CITY OF SUPERIOR, WISCONSIN
 DEPARTMENT OF PUBLIC WORKS

CONTRACT NO. 3
 LIFT STATION 5 AND STORAGE PLAN

CONTRACT NO. 3
LIFT STATION & STORAGE IMPROVEMENTS

LIFT STATION & STORAGE IMPROVEMENTS

SHEET G-3
 OF _____ SHEET
 PROJECT NO. 3899-03

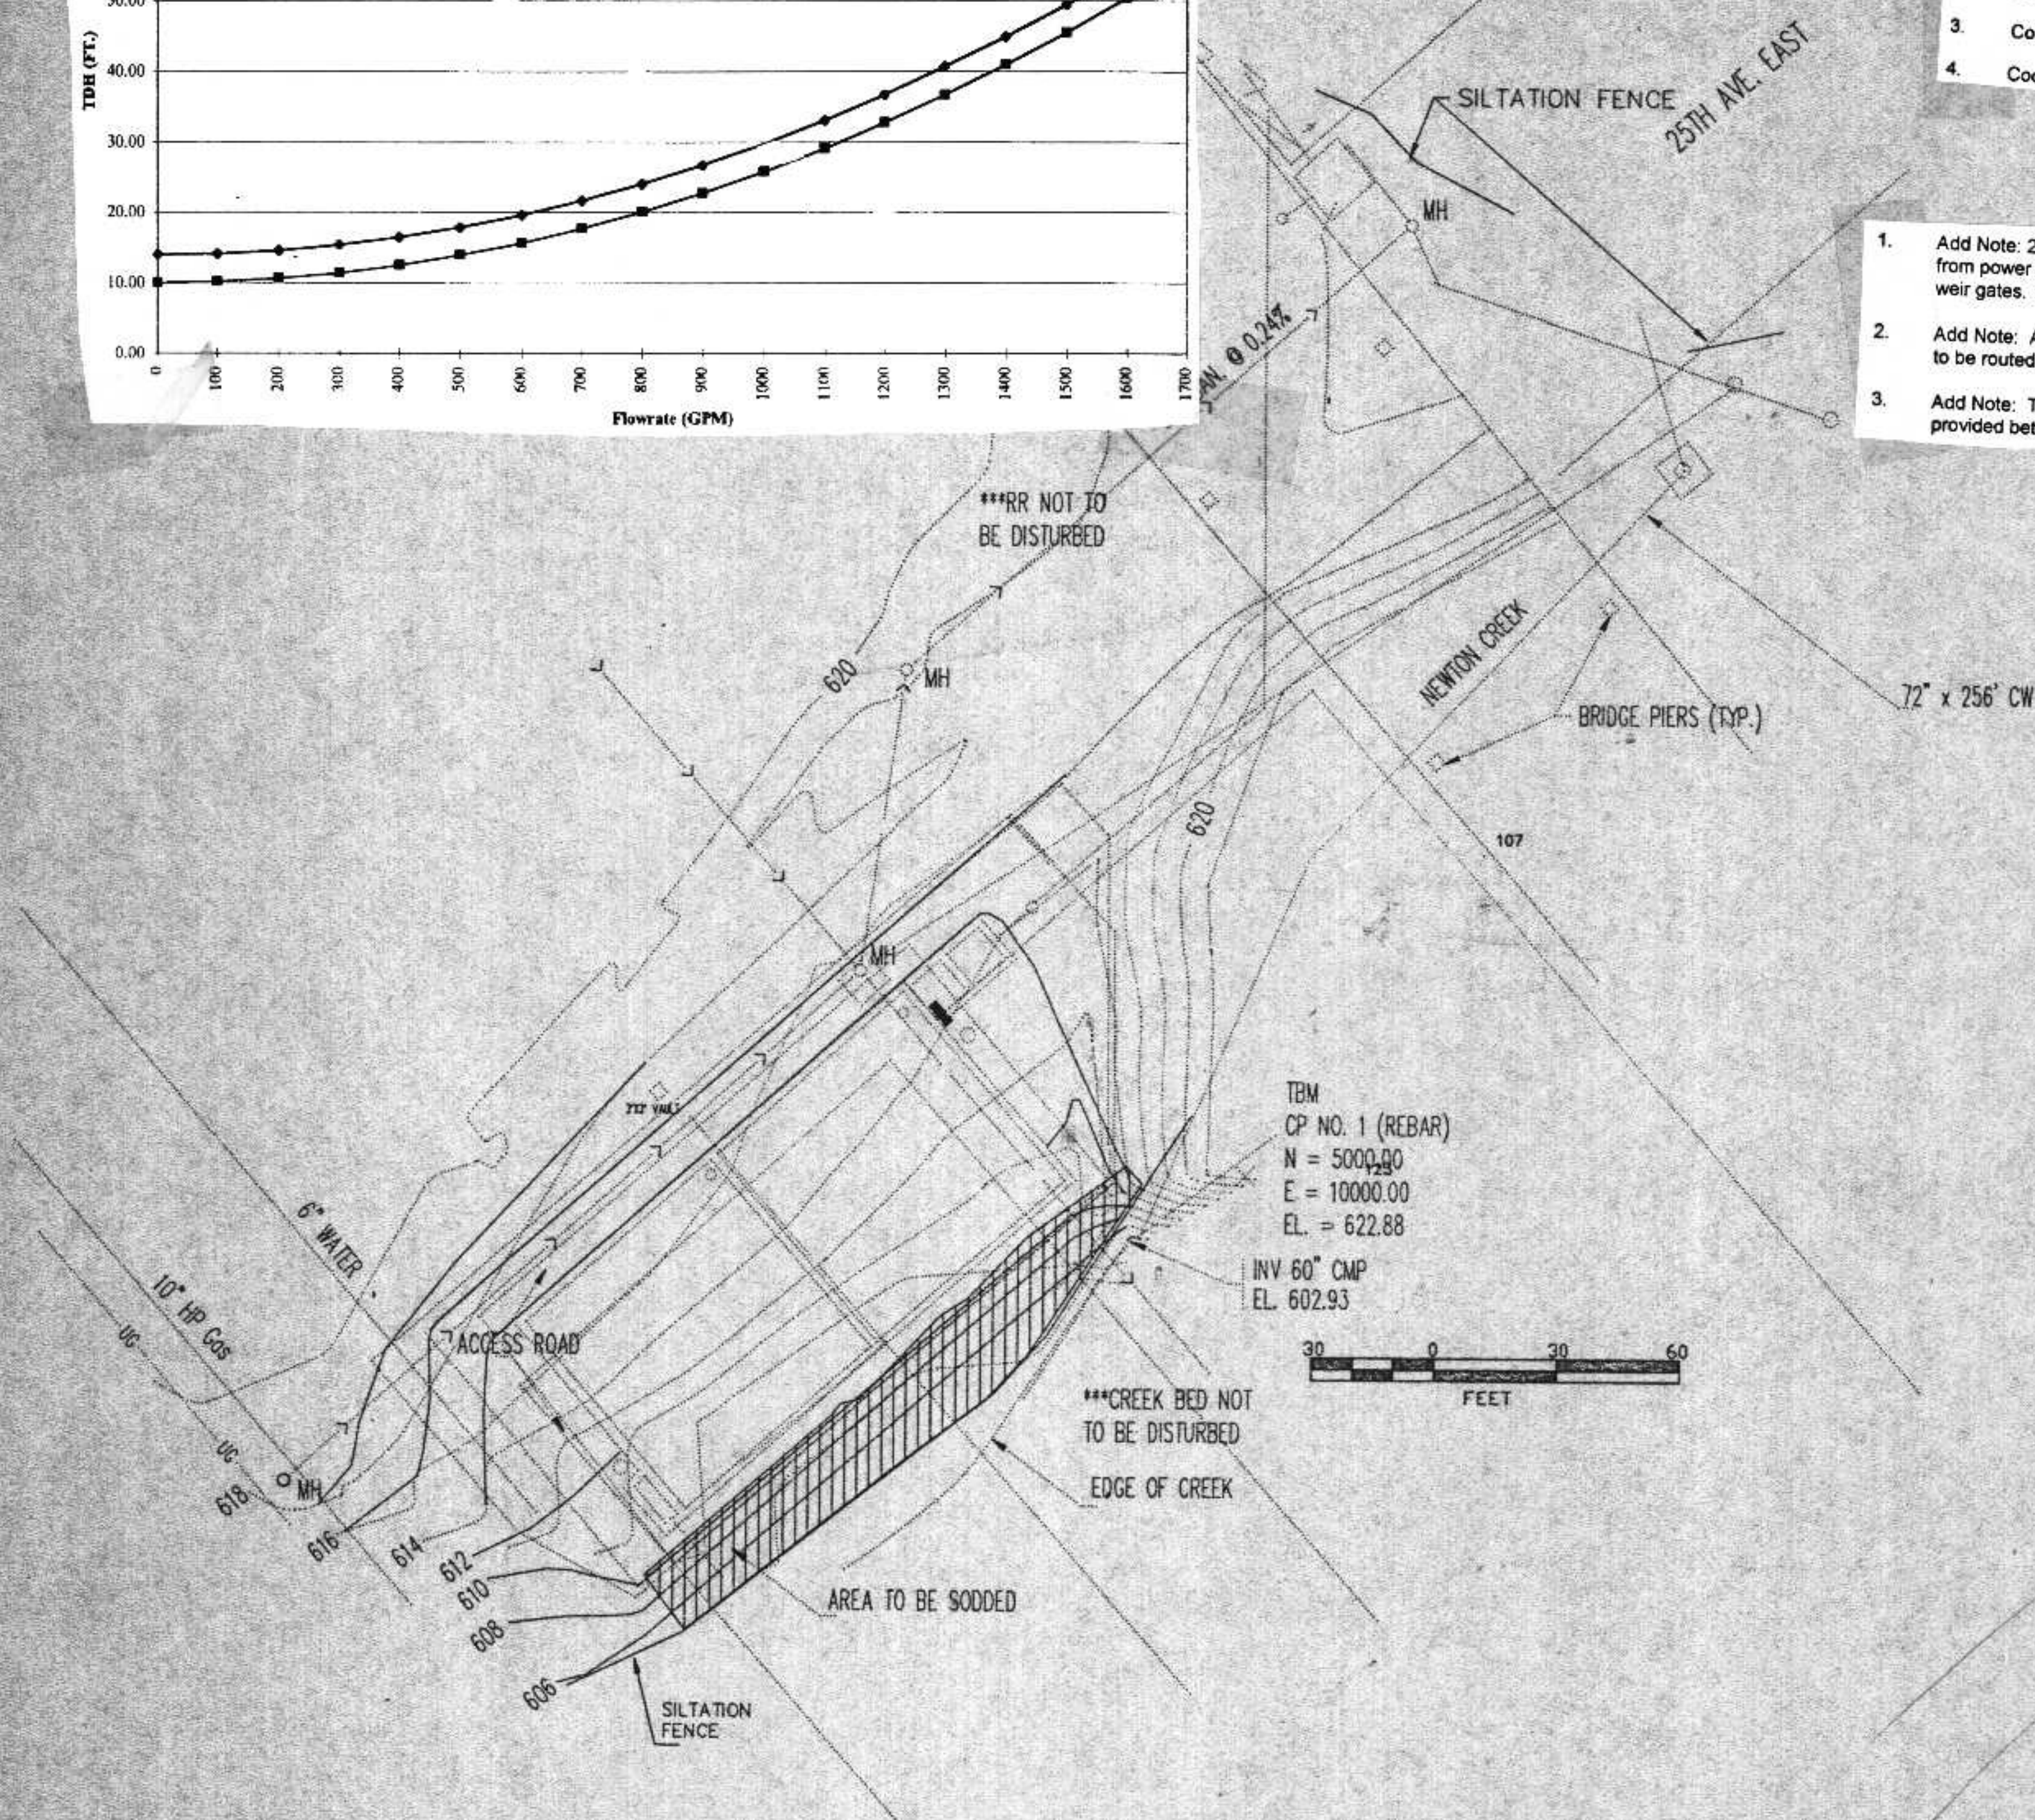
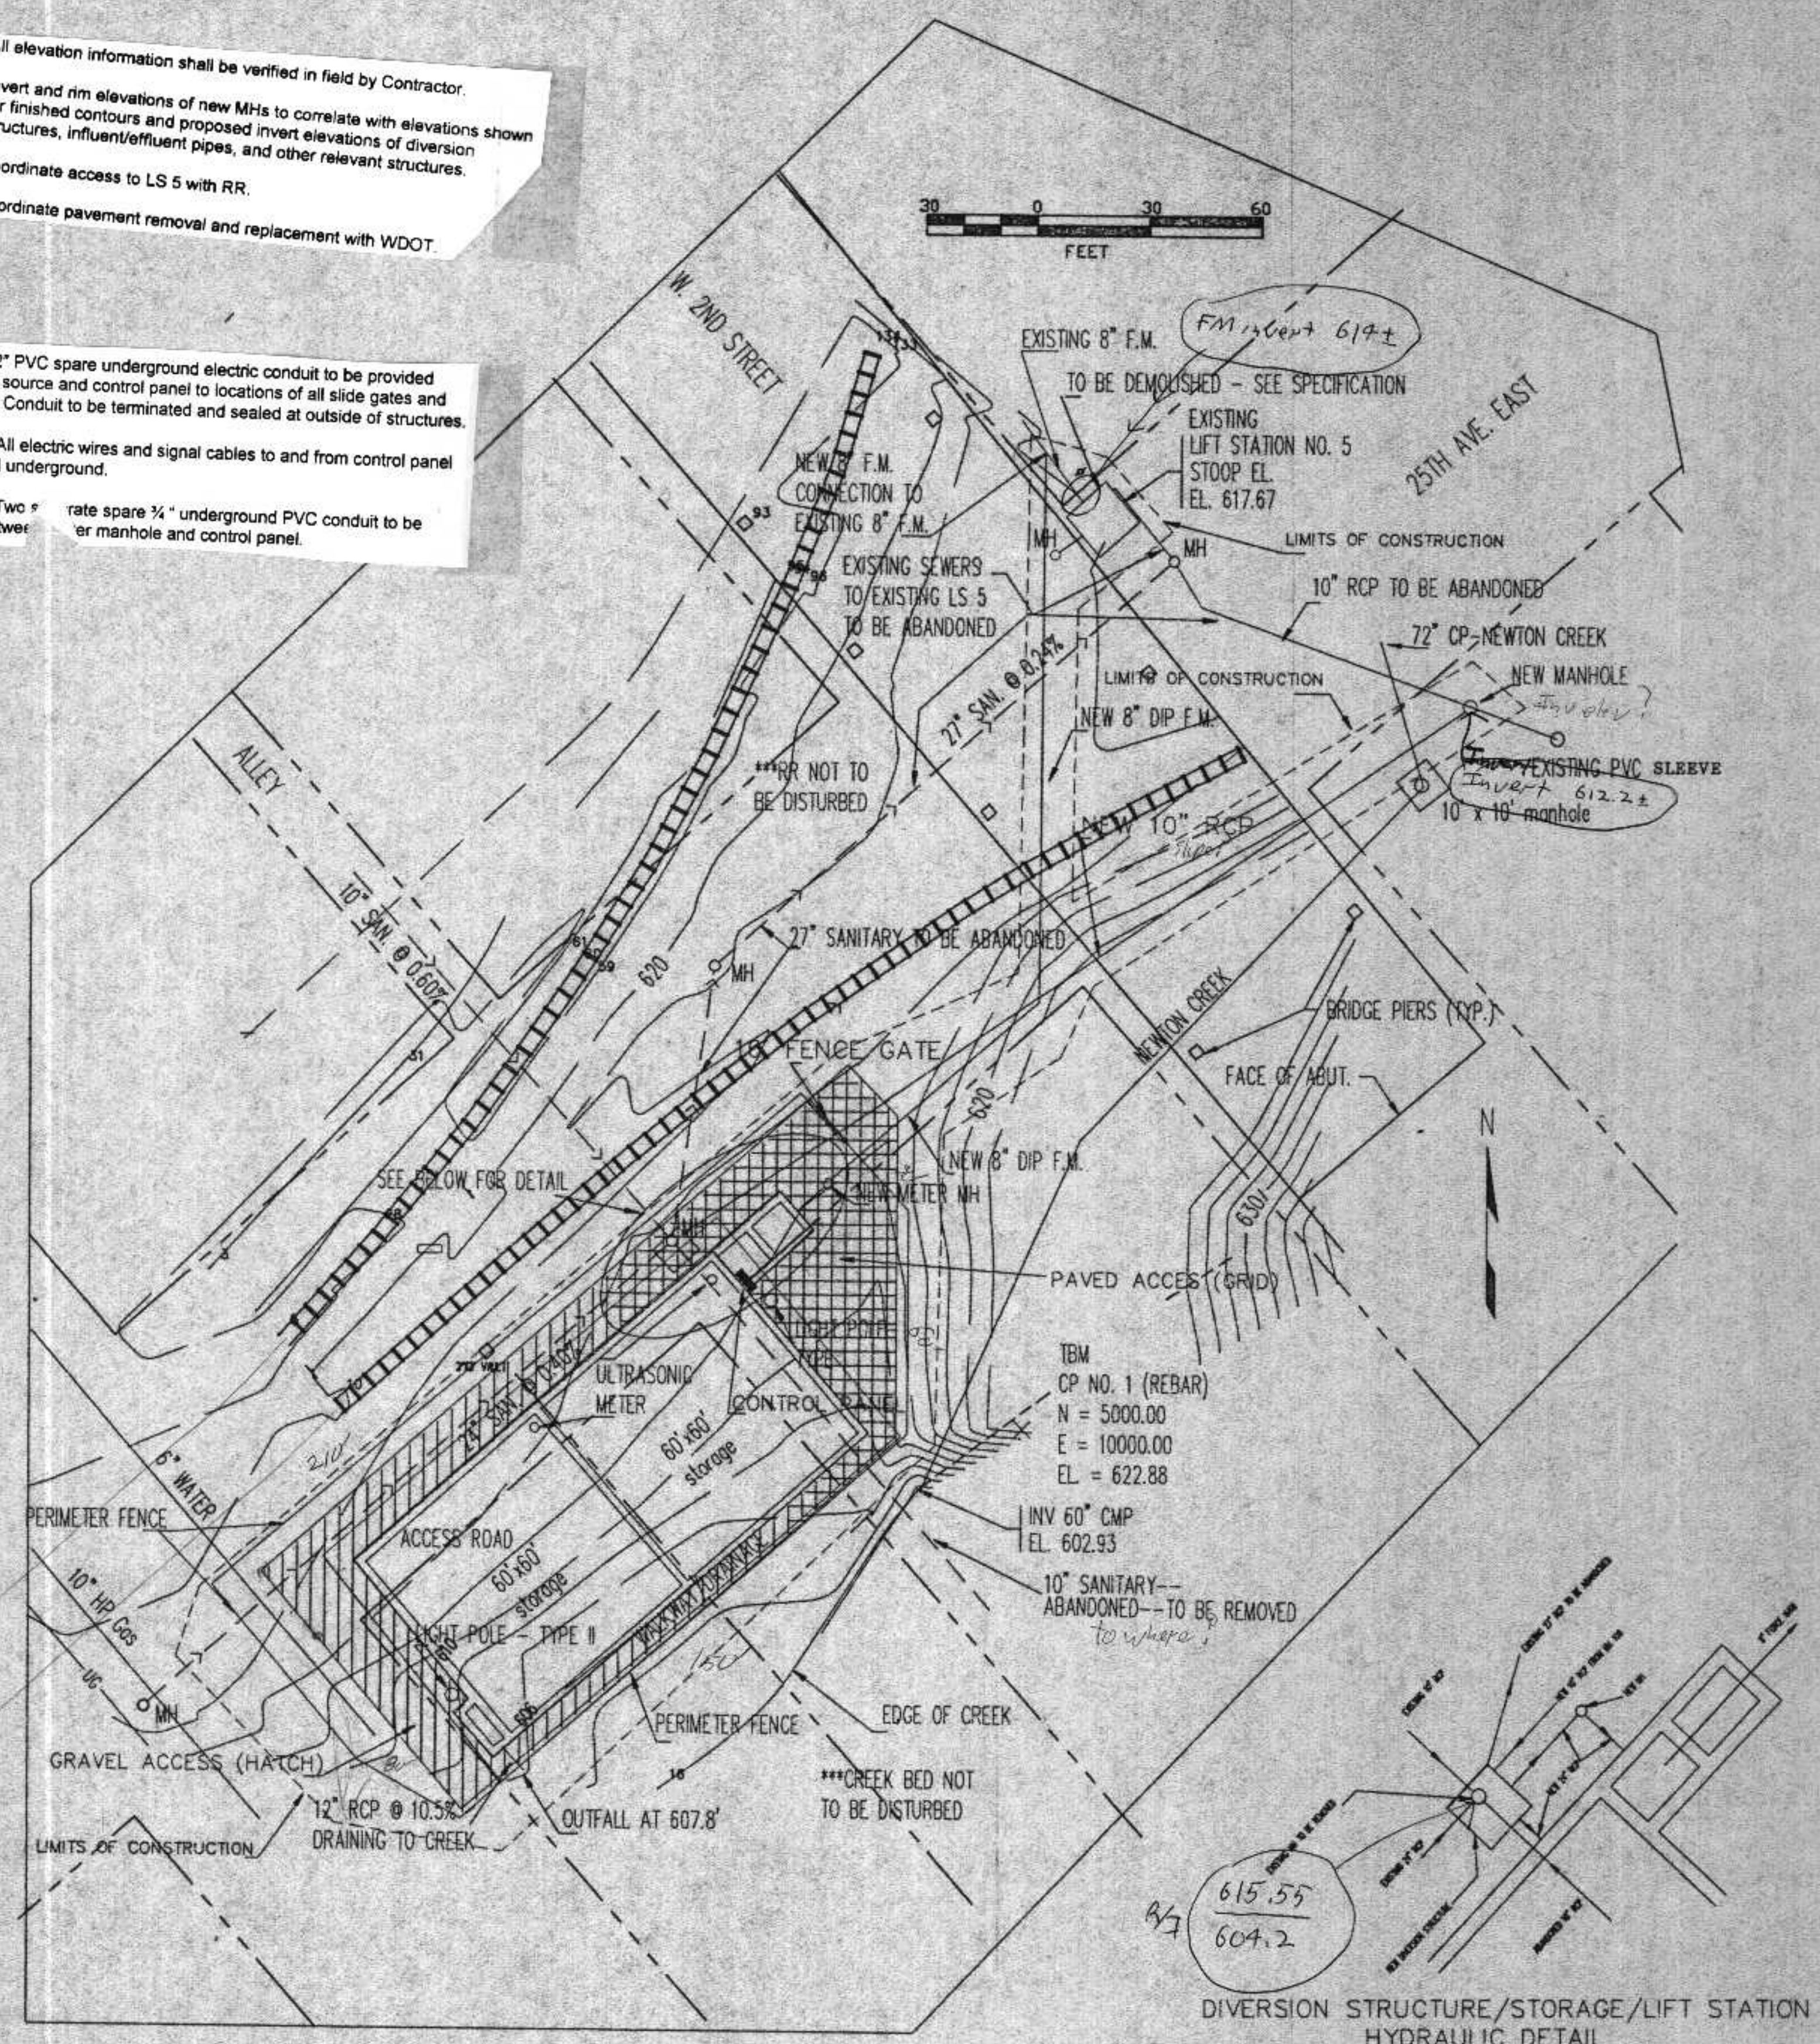
1. Add Note: 2" PVC spare underground electric conduit to be provided from power source and control panel to locations of all slide gates and weir gates. Conduit to be terminated and sealed at outside of structures.
2. Add Note: All electric wires and signal cables to and from control panel to be routed underground.
3. Add Note: Two 1/2" rate spare 1/2" underground PVC conduit to be provided between manhole and control panel.

METER MANHOLE

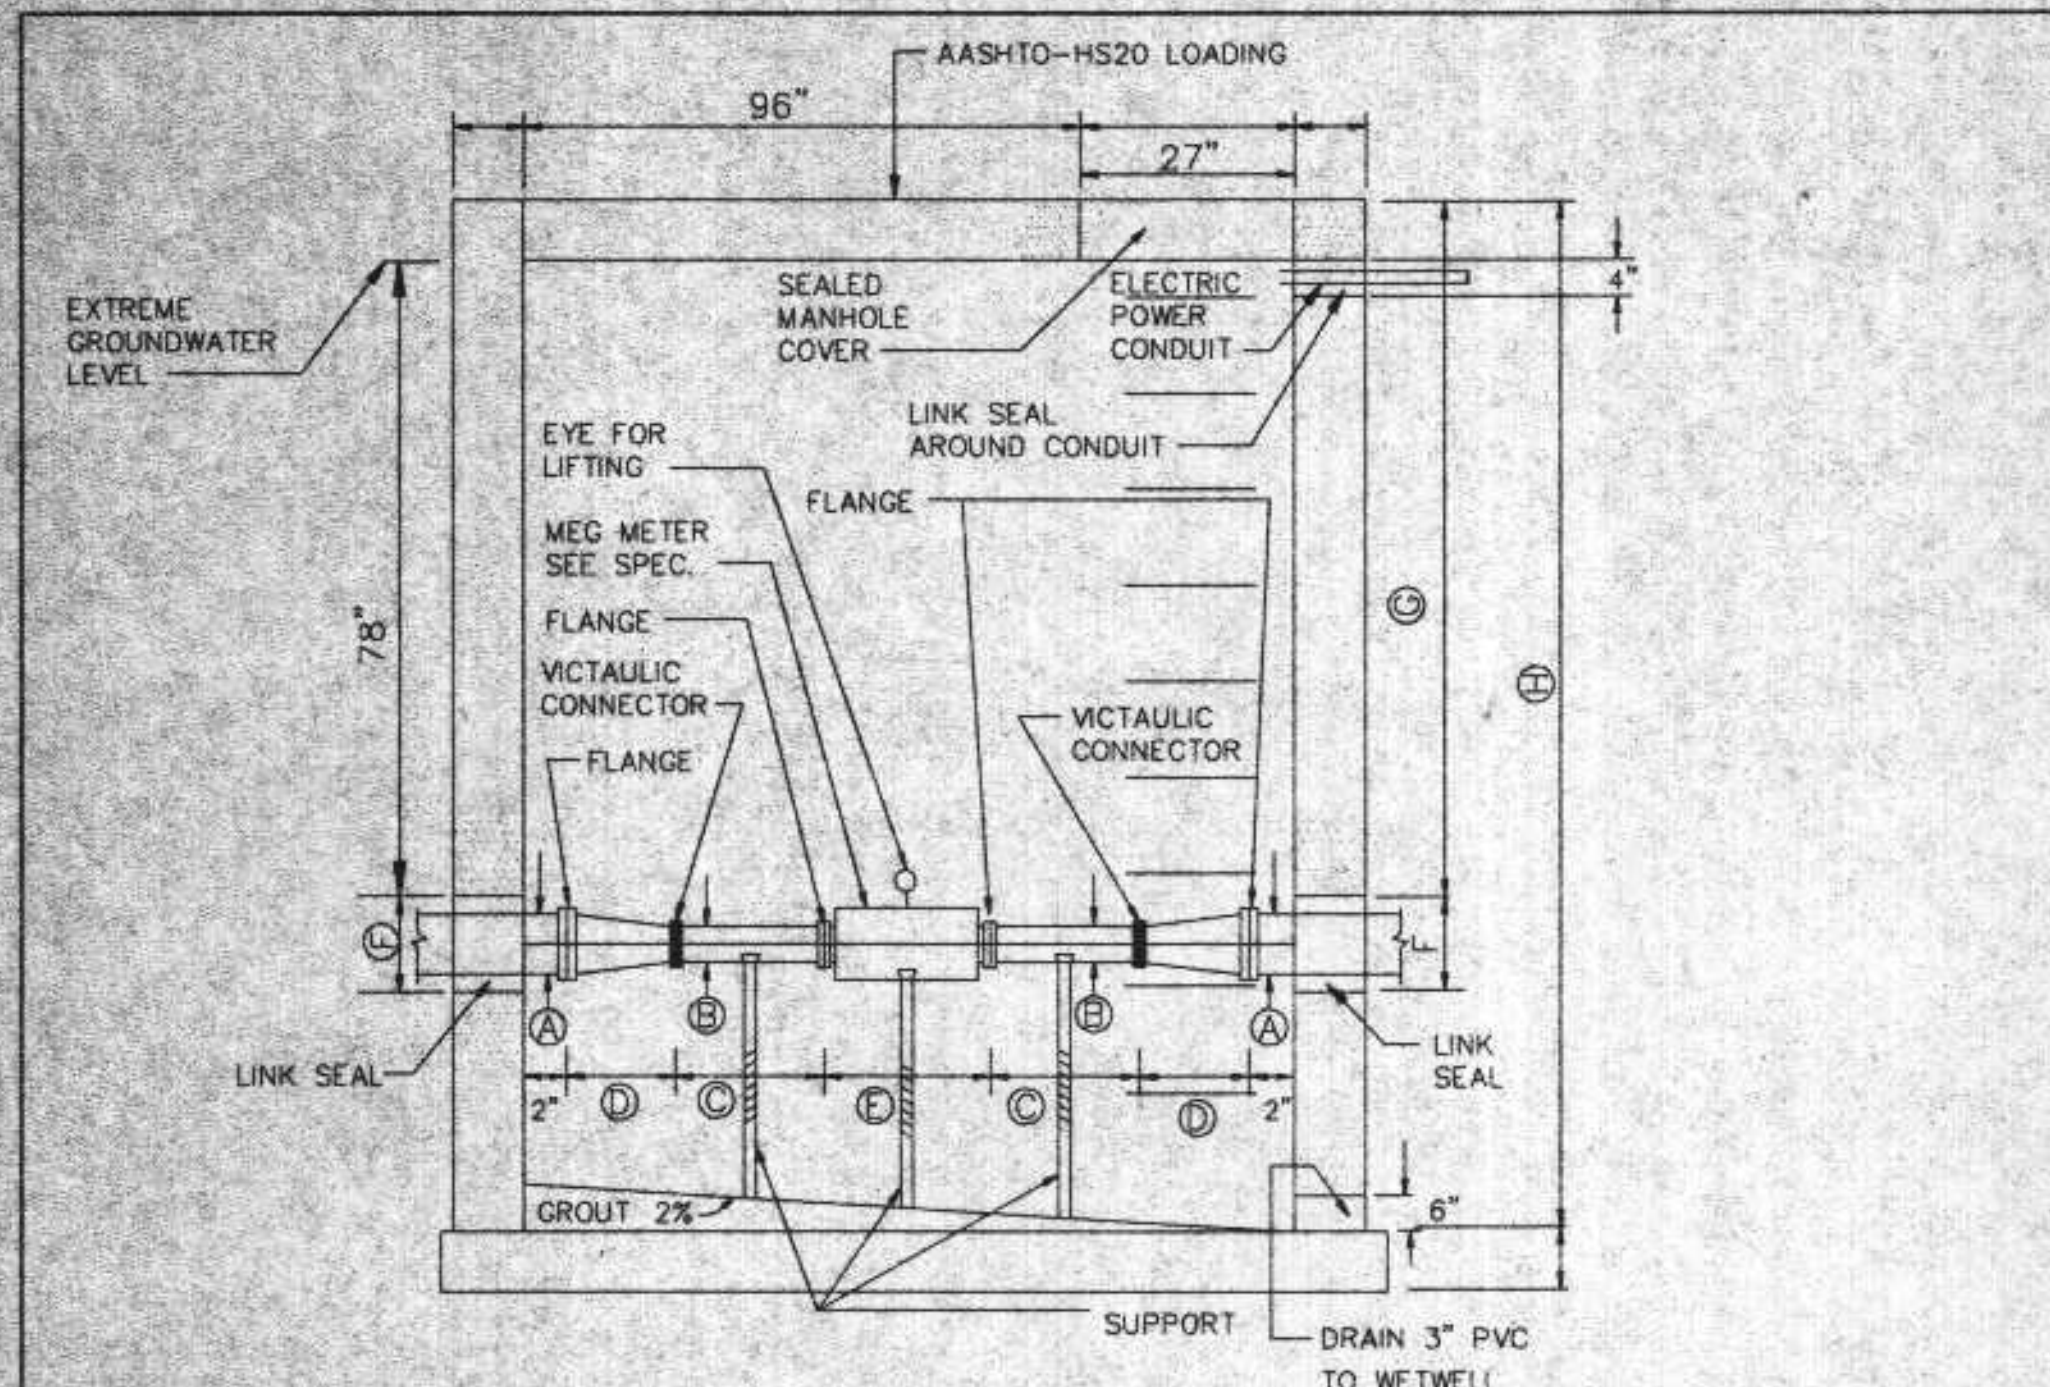
- Add following to meter manhole drawing:
